|  | STANDARD DESIGN - 40' ROADWAY, 3 SPAN BRIDGES<br><b>ROLLED STEEL BEAM BRIDGES</b><br>JUNE, 2010 |
|  | <b>ABUTMENT BACKFILL<br/>DETAILS, SKEWED</b>  |

**RS40-176-10**

**ABUTMENT PLAN WITH WING EXTENSIONS**

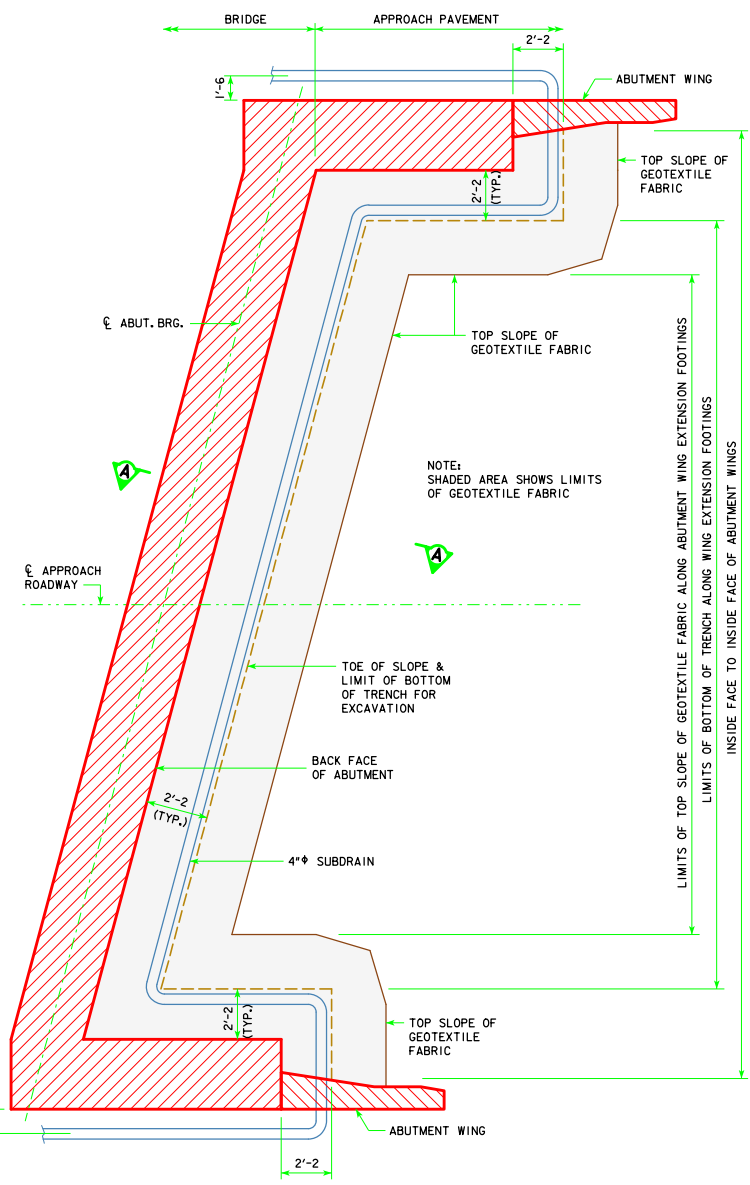
REVISED 04-12 - EXCAVATION LIMIT ON THE FRONT FACE OF ABUTMENT WAS CHANGED TO 3'-0".
